MONTGOMERY COUNTY HISTORIC PRESERVATION COMMISSION
STAFF REPORT

Address:	7120 Maple Ave., Takoma Park	Meeting Date:	2/11/2026
Resource:	Contributing Resource Takoma Park Historic District	Report Date:	2/4/2026
Applicant:	Jessica & Eli Williams-Szenes Brian McCarthy, Architect	Public Notice:	1/28/2026
Review:	HAWP	Tax Credit:	No
Case Number:	1074329 REVISION	Staff:	Dan Bruechert
Proposal:	Revisions to Basement Egress Window, Fenestration Alterations, Rear Porch Alterations

The applicant proposes to relocate the egress window and to alter an approved window assembly in the non-historic addition. Additionally, the applicant proposes to reduce the size of the approved rear porch.

Figure 4: Approved configuration (left) and revised proposal (right).

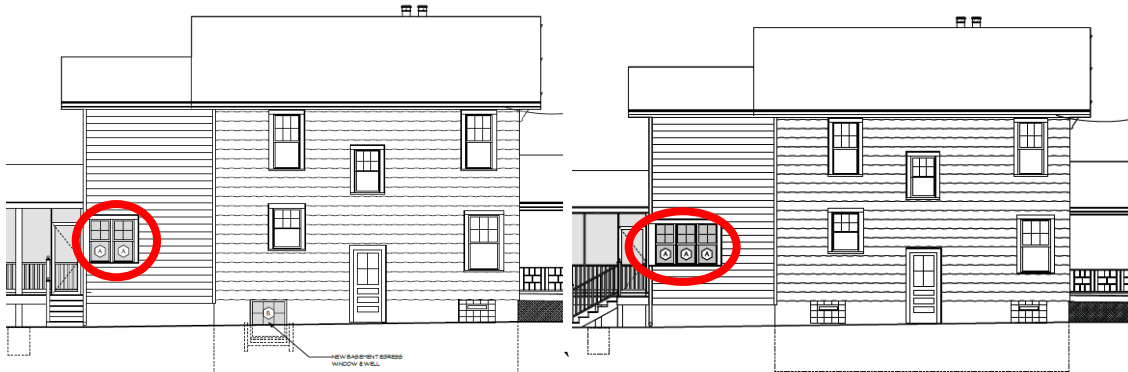
The applicant proposes to revise and expand this window opening to install a tripled window. The size, design, and material of the window is consistent with the approved Weathershield aluminum clad window.

Staff finds the window material, aluminum-clad wood, and the configuration, four-over-one sash windows is appropriate for the character of the house and surrounding district and Staff recommends the HPC approve the new windows under 24A8(b)(2) and (d); the *Design Guidelines*; and *Standards 2, 9, and 10*.

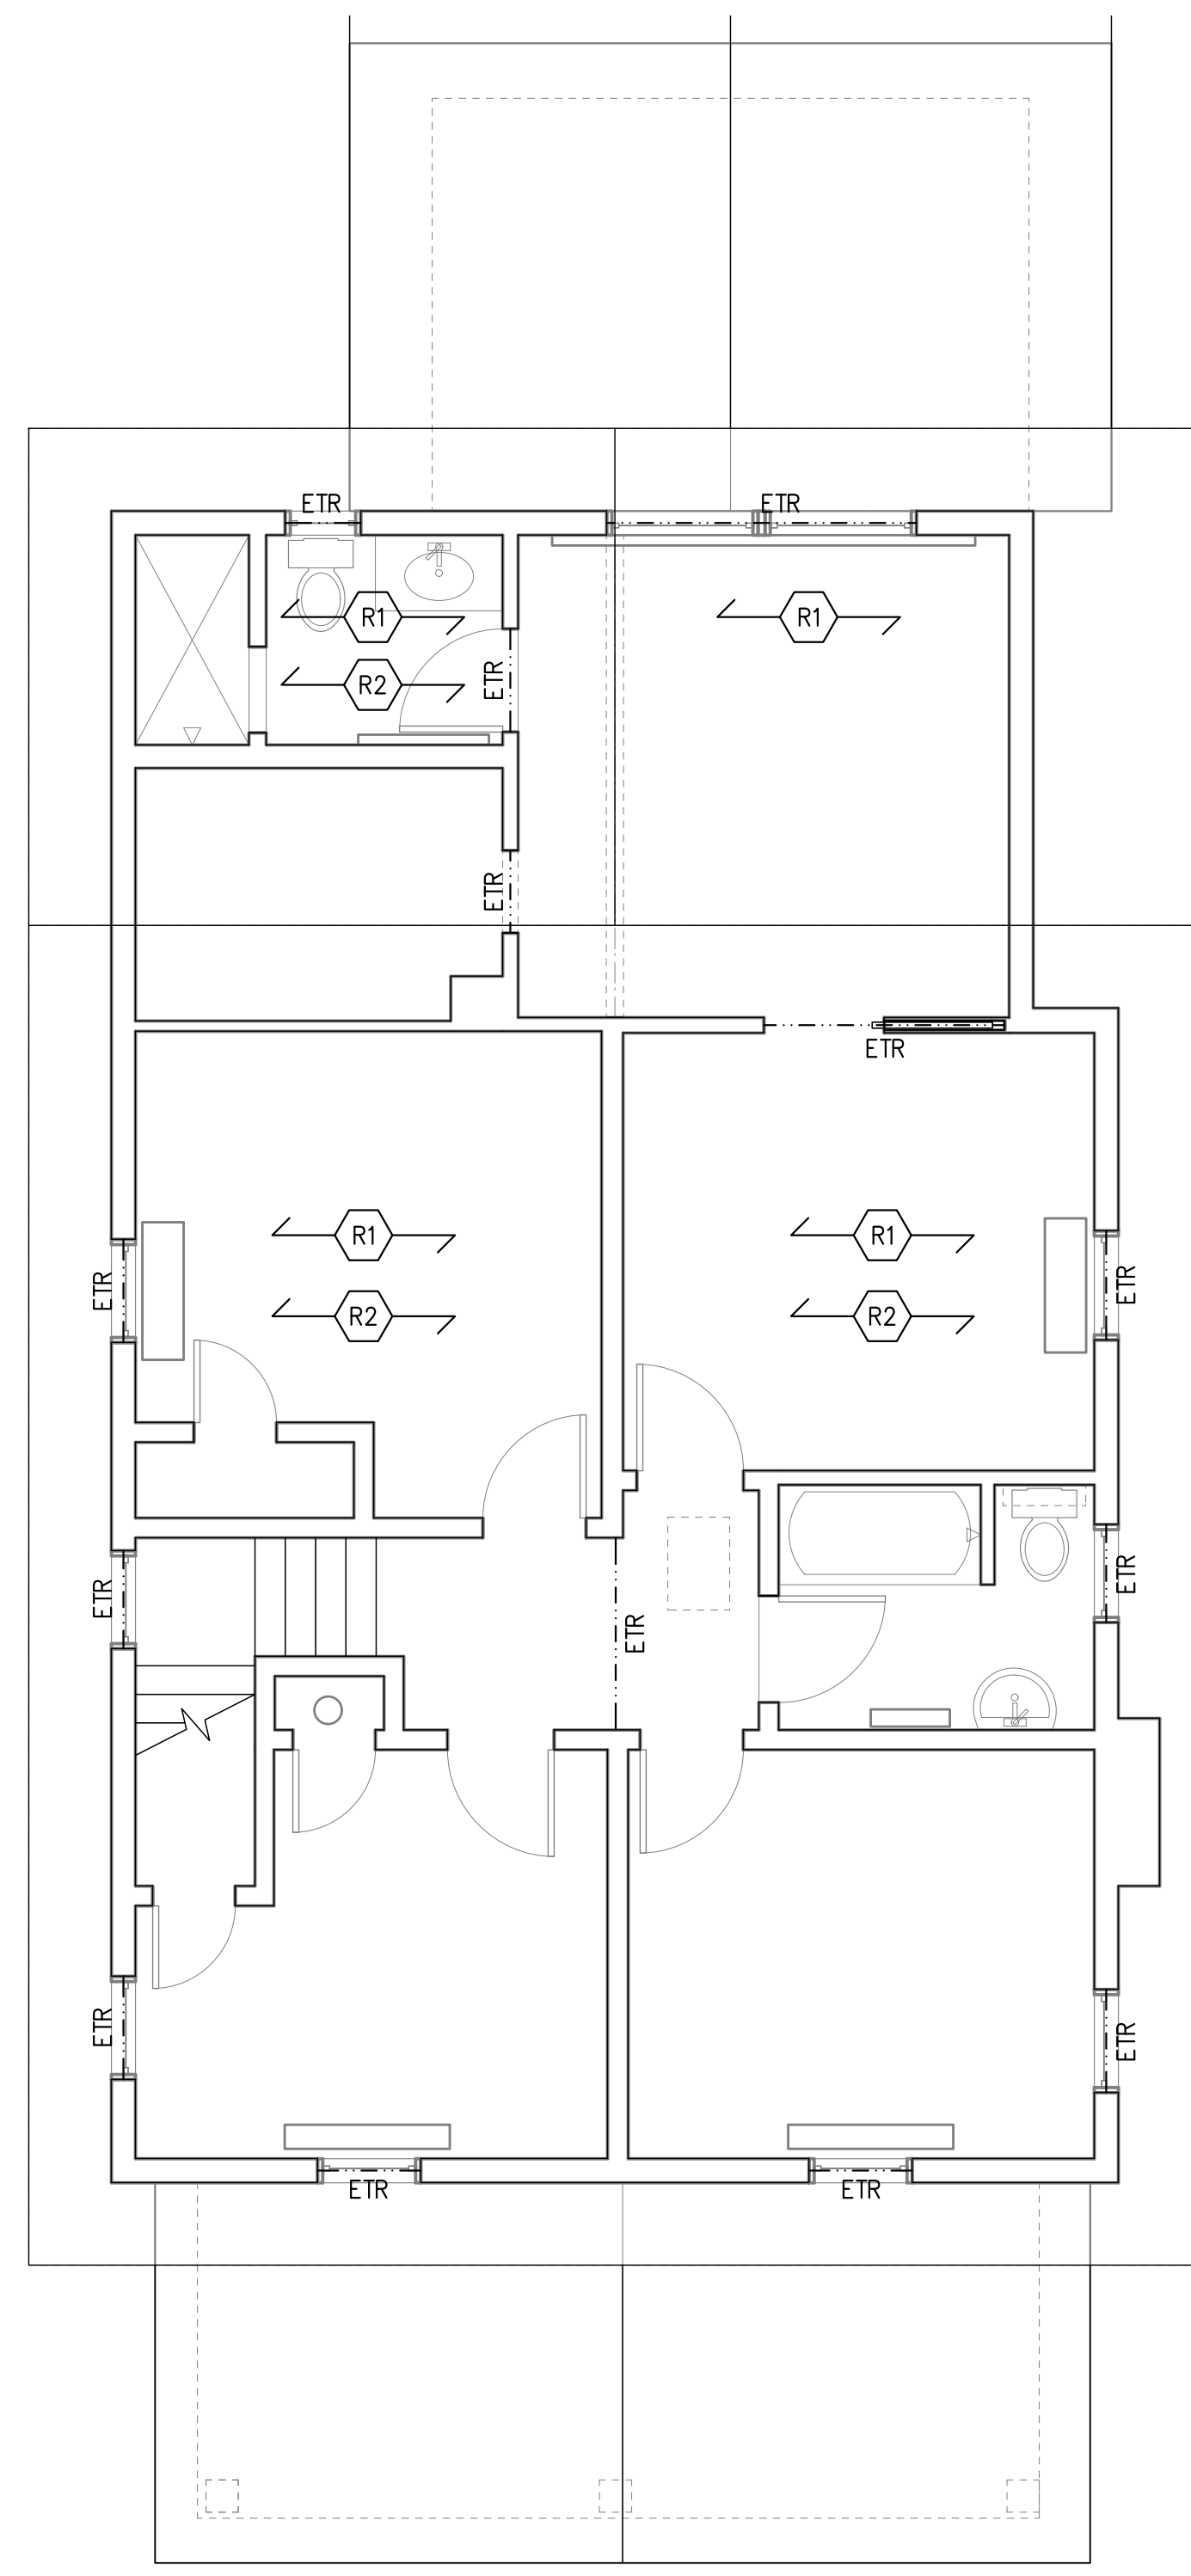
We removed center post and upsized beams to (3)2X10 Will that work?

Detail at Key Note S8

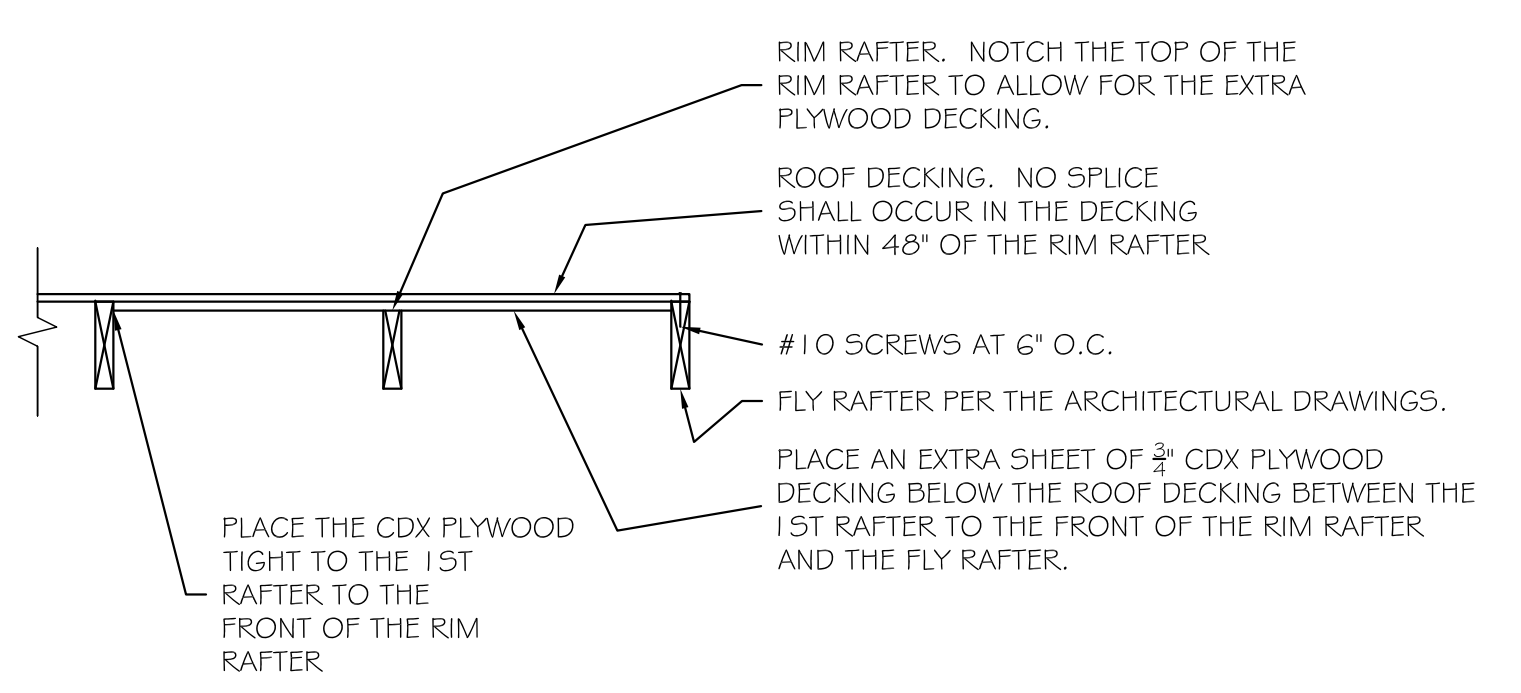
*2x4 framing
reduce corner post to 4x4?*
